Project	IEEE 802.16 Broadband Wireless Access Working Group < <u>http://ieee802.org/16</u> > Pilot Allocation in Downlink PUSC – Reply to Comments #169, #170	
Title		
Date Submitted	2004-08-21	
Source(s)	Ran Yaniv, Tal Kaitz, Naftali Chayat, Vladimir Yanover, Marianna Goldhammer	Voice: +972-37674583
	Alvarion Ltd.	mailto: <u>ran.yaniv@alvarion.com</u>
	Wonil Roh, JeongTae Oh, Chan-Byoung Chae, Kyunbyoung Ko, Hongsil Jeong, Sung-Ryul Yun	mailto: wonil.roh@samsung.com
	Samsung Electronics Co., Ltd.

Pilot Allocation in Downlink PUSC: Reply to Comments #169, #170

Figure 1 – Current definition of DL PUSC clusters for 2-antenna STC

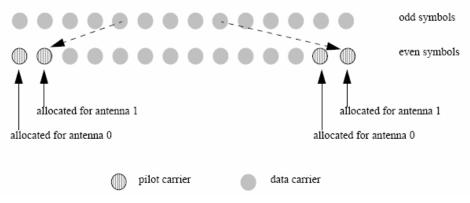
The pilot spacing of 12 subcarriers leads to very significant channel estimation loss in the presence of channels with relatively high delay spread (delay spread that is however much smaller than the maximum supported cyclic prefix length) when using pilot-aided estimation approaches. Since the goal of STC schemes is to extend the cell range, it is important that they operate well at cell edges, where high delay spread is very likely. Note that in STC mode we can not rely on channel estimation from the DL preamble since the preamble is transmitted by only one antenna.

In effect, estimation loss in highly dispersive channels will severely limit data transfer rate to as low as QPSK modulation using ¹/₄ coding rate, <u>regardless of thermal noise level</u>. A solution to this problem is presented in section 2. A by-product of this solution is the fact that two contiguous symbols, rather than slots, can be STC encoded – this is beneficial in situations where the channel is time-varying.

Figure 3 – STC usage with 2-Antennas in DL-PUSC.

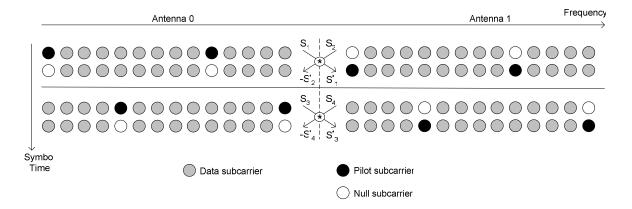
2. STC encoding of subcarriers shall be performed between contiguous symbols rather than between contiguous slots. This is depicted in the following figure:

Figure 6 - Comparison between current and proposed DL PUSC structures in STC mode, $\tau_{\max} = \frac{1}{16} \cdot T_{sym} \cdot$

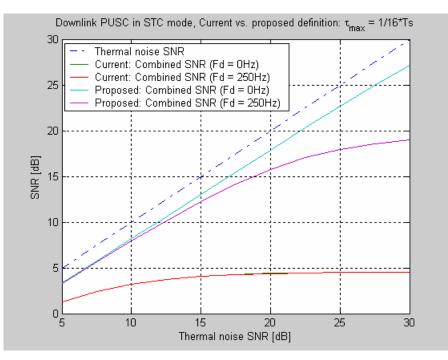
The proposed cluster structure does indeed solve the severe estimation problem for the PUSC STC modes. This is shown in Figure 6 and Figure 7.

Figure 246 – STC usage with PUSC

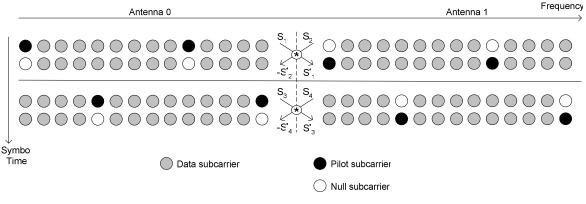
[Replace figure 246 on page 584 with the following figure:]

In PUSC the data allocation to cluster is changed (Figure 245) to accommodate two antennas transmission with the same estimation capabilities, each cluster shall be transmitted twice from each antenna from both antennas.

The clusters composing the subchannels used by the STC mode shall be allocated and subcarriers numbered as defined in 8.4.6.2 with pilots in each consecutive quartet of PUSC symbols allocated as depicted in figure 245. The cluster structure of the subchannels allocated for STC is slightly modified to fit the STC requirments. The structure shall be modified as depicted in Figure 245 (switching 2 pilot carriers from the odd symbol with 2 data carriers from the even symbols, switching of the data carriers and the pilots carriers shall be performed after constellation mapping, therefore maintaining all the encoding scheme and the subchannel allocation scheme). In this scheme, transmission on regular subchannels and STC subchannels is possible and is determined by the MAC layer (the allocation is performed by allocating major groups of subchannels for regular or STC transmission). The transmission <u>STC encoding</u> of the data shall be performed <u>in pairs of symbols</u> as illustrated in Figure 246. The number of OFDMA symbols in a PUSC STC-encoded allocation shall be a multiple of four.
